Docket Item # 9
BAR CASE # 2009-0105

BAR Meeting
June 17, 2009

ISSUE: New Construction (Garage)

LOCATION: 1221 Prince Street

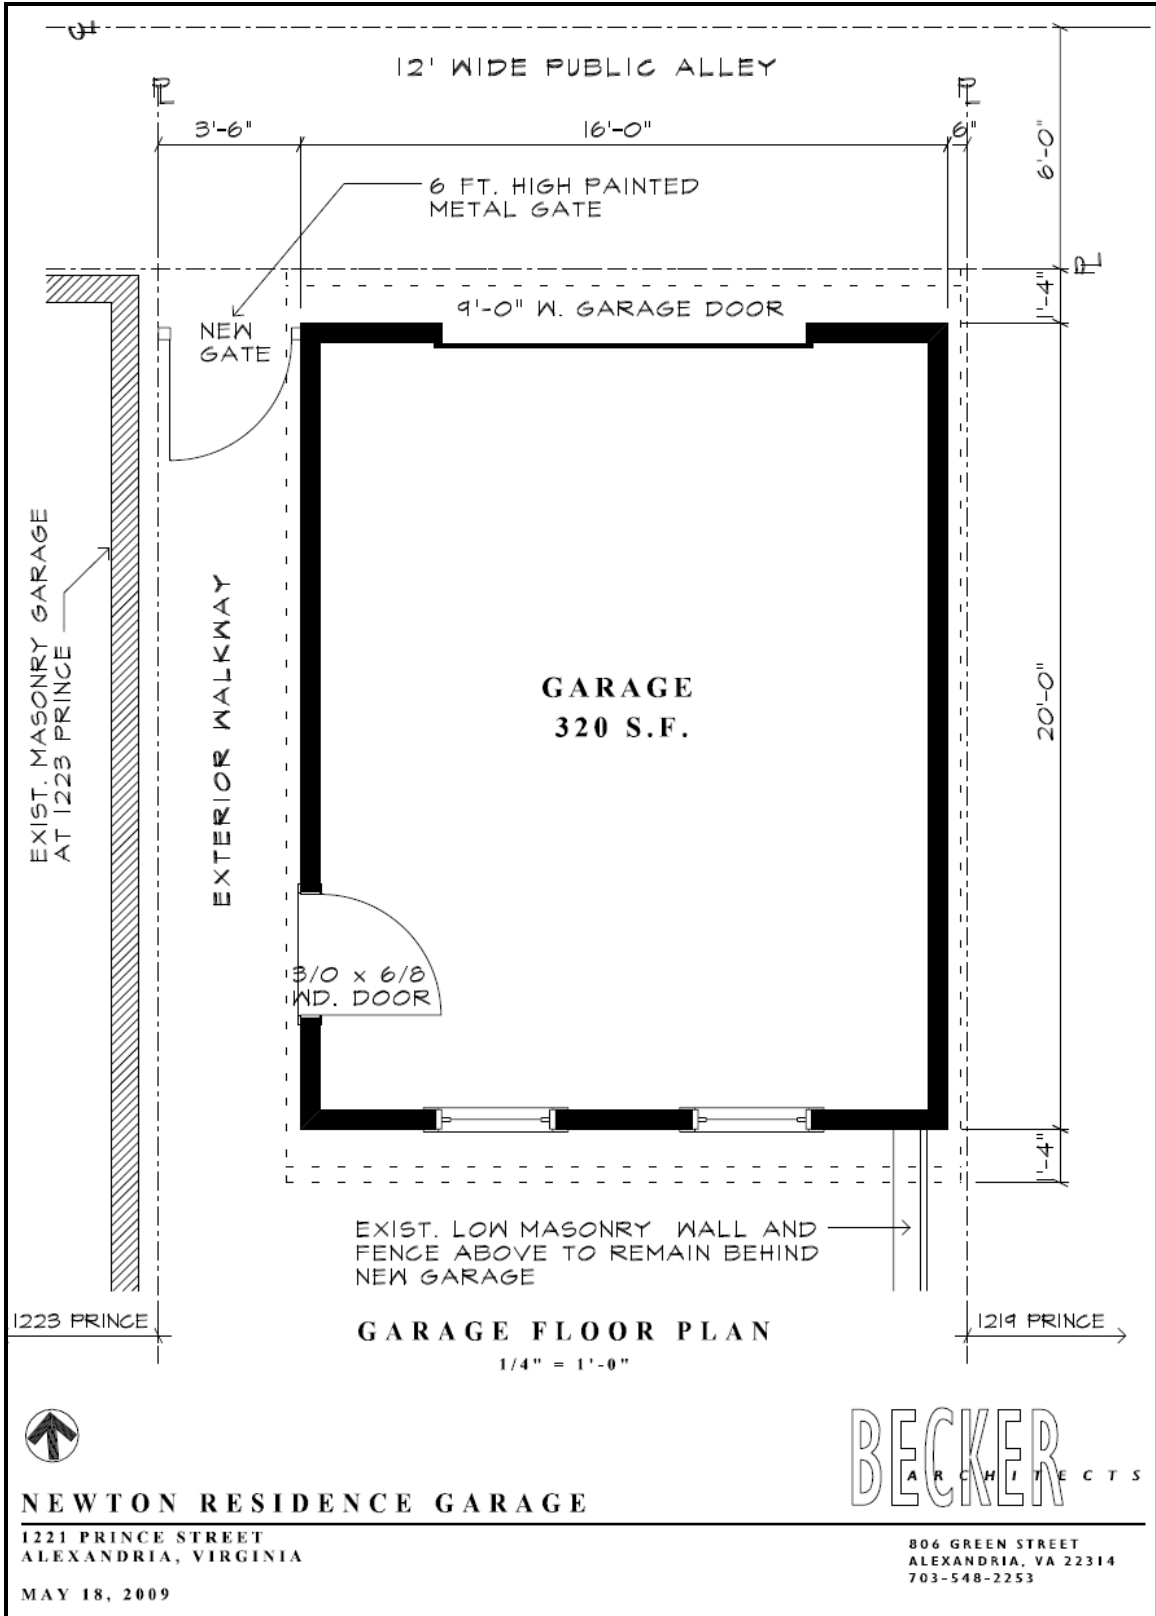
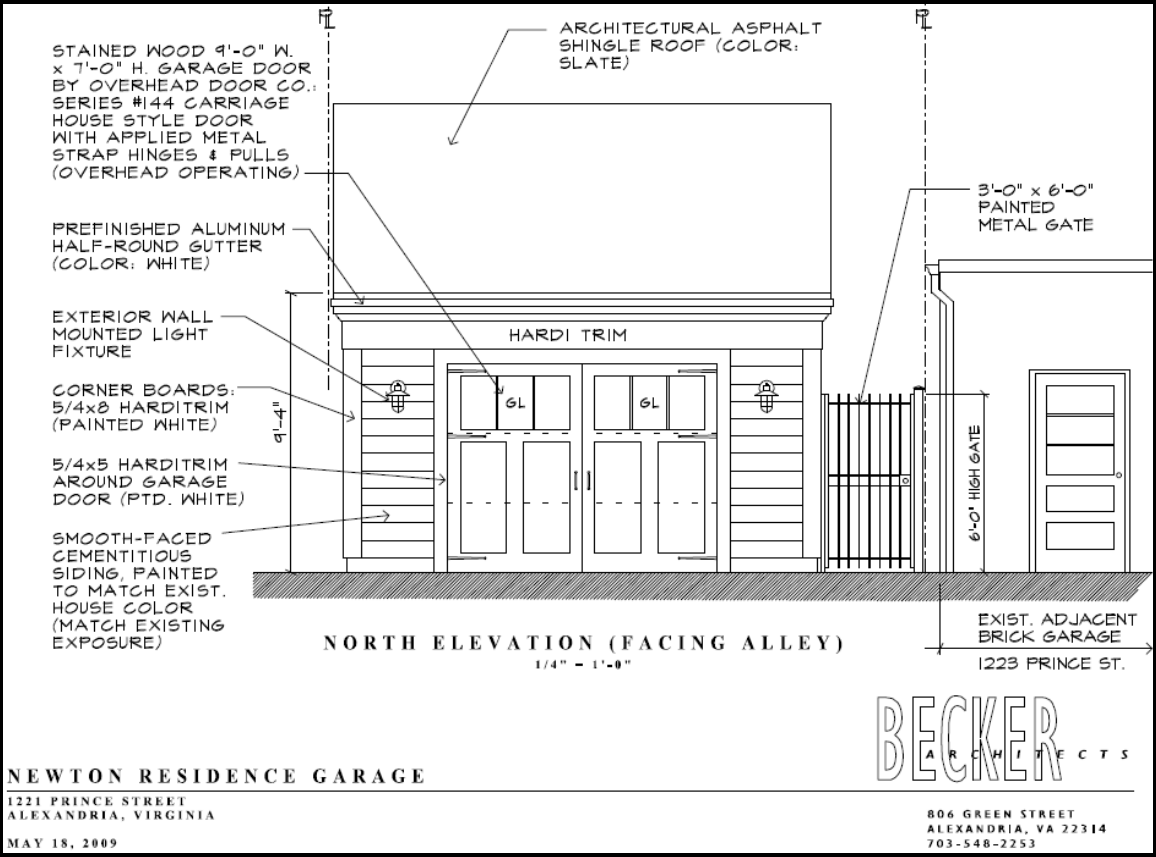
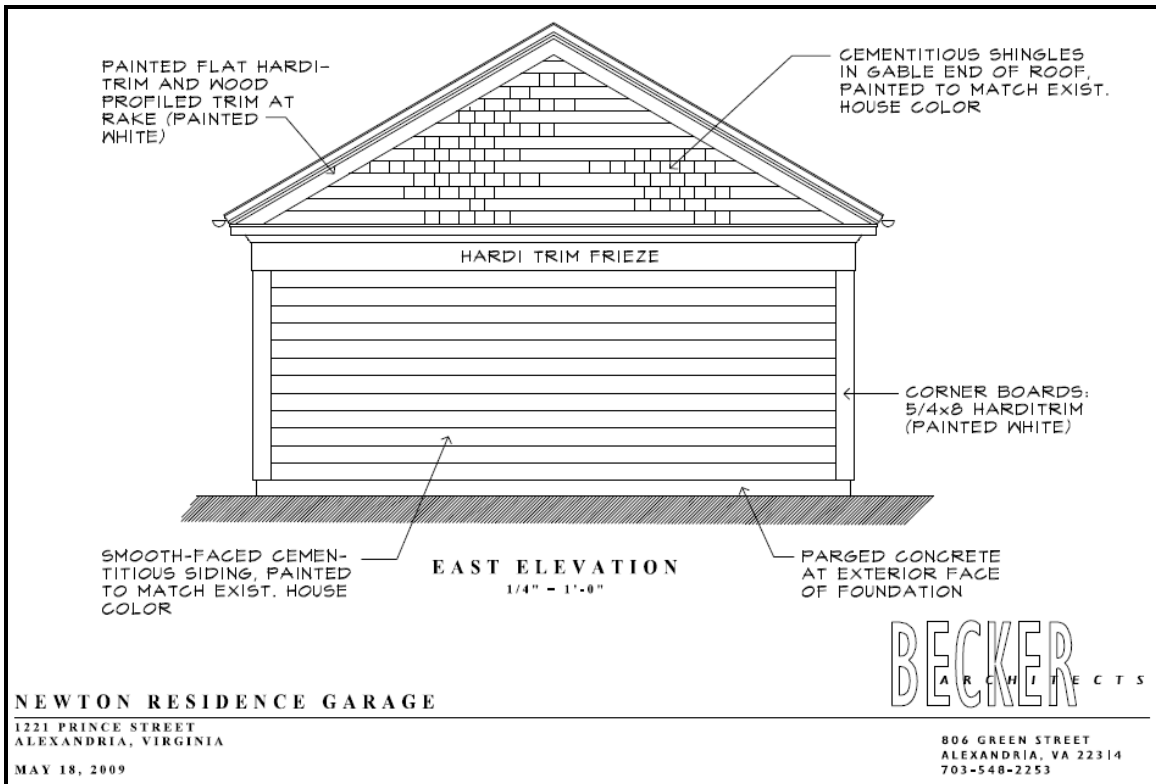
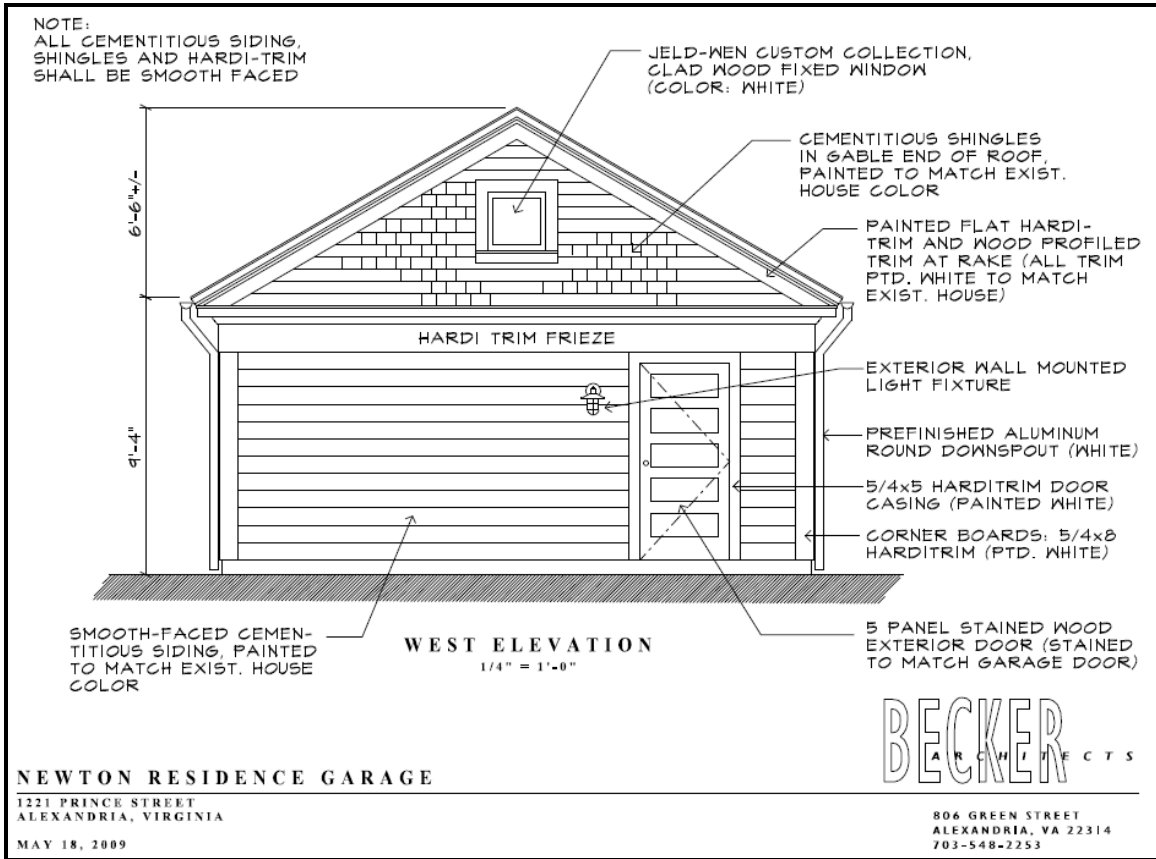
While fiber cement products, when painted, closely resemble traditional wood, Staff does not believe that aluminum clad windows provide the same level of quality. While the Board often recommends approval of double-insulated, simulated divided light windows on additions and new construction, the *Design Guidelines* strongly discourage metal clad

windows. In 2006, the Board conditioned their approval of the addition on the installation of wood windows instead of the aluminum clad windows requested by the applicant. Staff recommends that the proposed windows be wood and not aluminum clad.

- C-1 All exterior walls within 5 feet from an interior property line shall have a fire resistance rating of 1 hour, from both sides of the wall. As alternative, a 2 hour fire wall may be provided. This condition is also applicable to skylights within setback distance. Openings in exterior walls between 3 and 5 feet shall not exceed 25% of the area of the entire wall surface (This shall include bay windows). Openings shall not be permitted in exterior walls within 3 feet of an interior lot line.

1. The windows on the garage be constructed of wood and not aluminum clad wood;
2. The nails not show in the installation of the smooth fiber cement material; and,
